FORD TECHNICAL SERVICE BULLETIN 03-16-1

Engine Controls/Fuel System - MIL ON/DTC's P0171/P0174

**Article No.
03-16-1**

**FORD:
1999-2003 WINDSTAR**

Figure 1

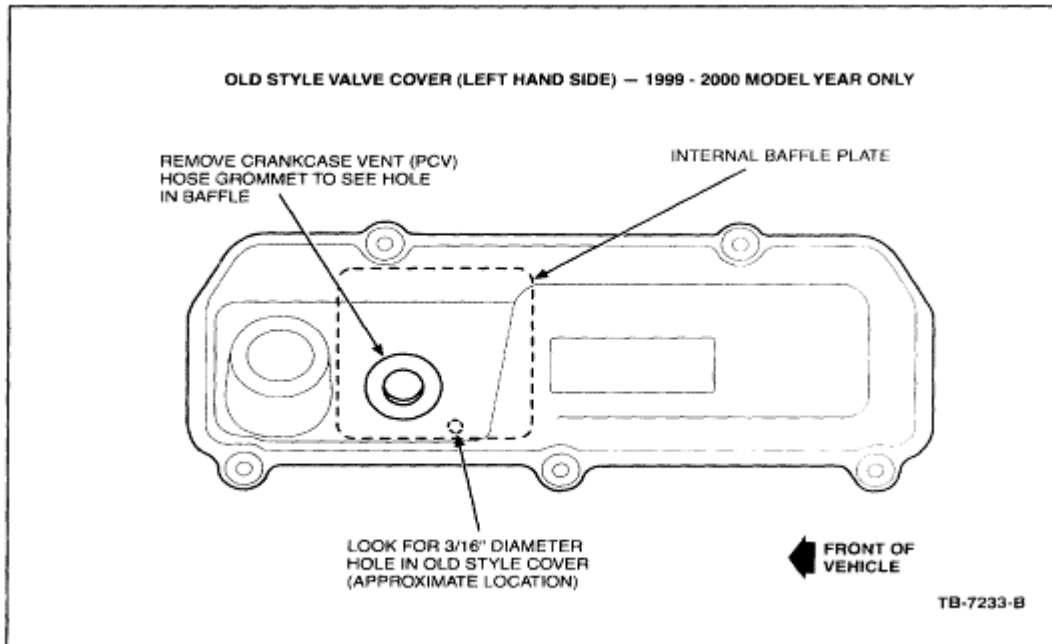
NOTE USING A SHOP LIGHT OR FLASHLIGHT, CHECK THE LH VALVE COVER TO SEE IF IT HAS ALREADY BEEN UPDATED TO THE LATEST LEVEL. REMOVE THE PCV VALVE AND RUBBER GROMMET FROM THE VALVE COVER AND LOOK THROUGH THE HOLE AT THE INTERNAL SHEET METAL BAFFLE. THE OLD STYLE VALVE COVER BAFFLE HAS A 3/16" DIAMETER HOLE IN THE 5:00 O'CLOCK POSITION AS YOU LOOK THROUGH THE PCV HOLE (FIGURE 1). VALVE COVERS FITTING THIS DESCRIPTION MUST BE REPLACED.
